Document Update Notification

DOCUMENT NO: OP-1903.010

TITLE: EMERGENCY ACTION LEVEL
CLASSIFICATION

CHANGE NO: PC-04

ATTACHMENT 5
UNIT 1

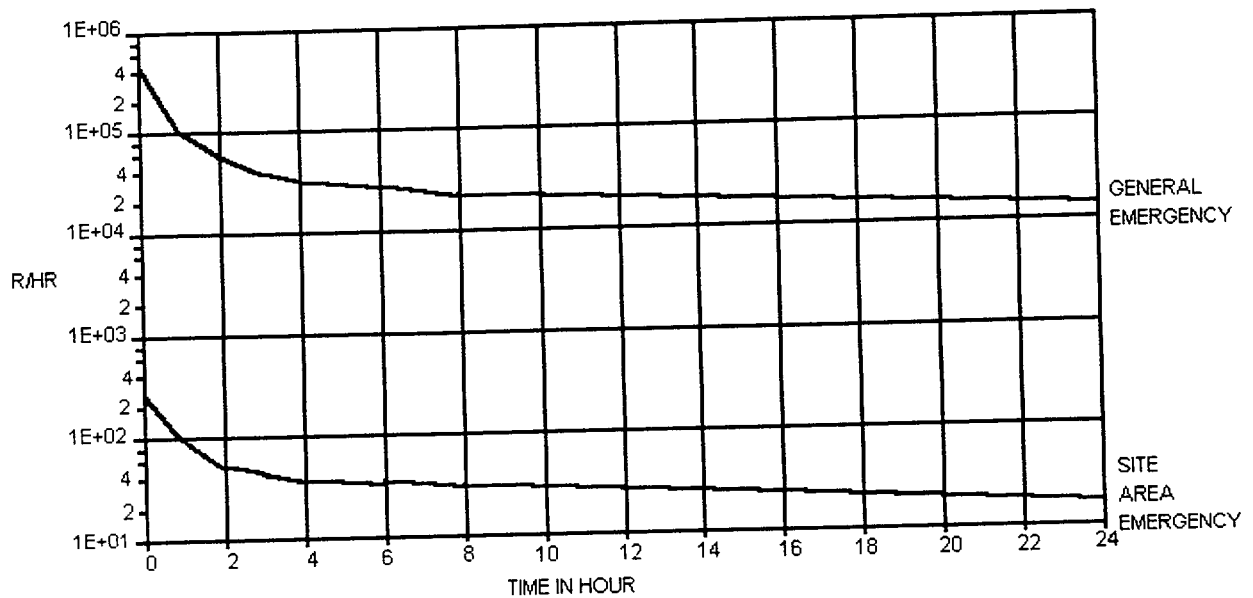
Added note to clarify the differences in the failed fuel graphs in 1903.010 and 1903.011.

NOTE:
This graph corresponds with 1903.011 Attachment 7 (WITH Spray), SAE equals 1% Clad Failure and GE equals 50% Fuel Overheat.

ATTACHMENT 6
UNIT 2

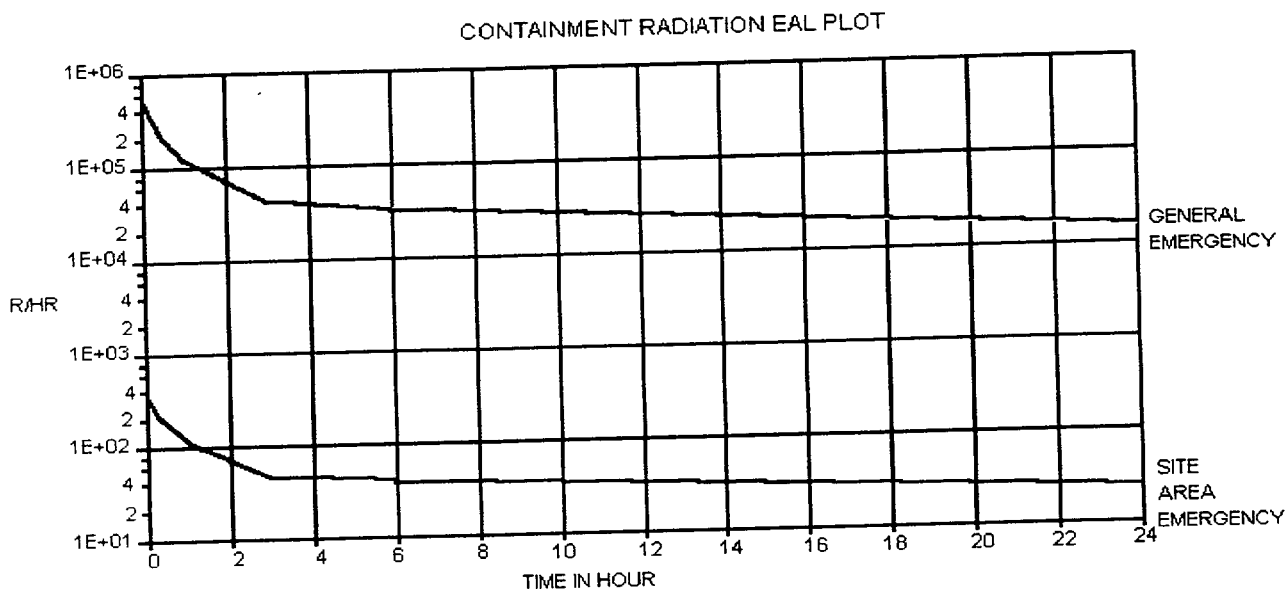
Added note to clarify the differences in the failed fuel graphs in 1903.010 and 1903.011.

NOTE:
This graph corresponds with 1903.011 Attachment 8 (WITH Spray), SAE equals 1% Clad Failure and GE equals 50% Fuel Overheat.
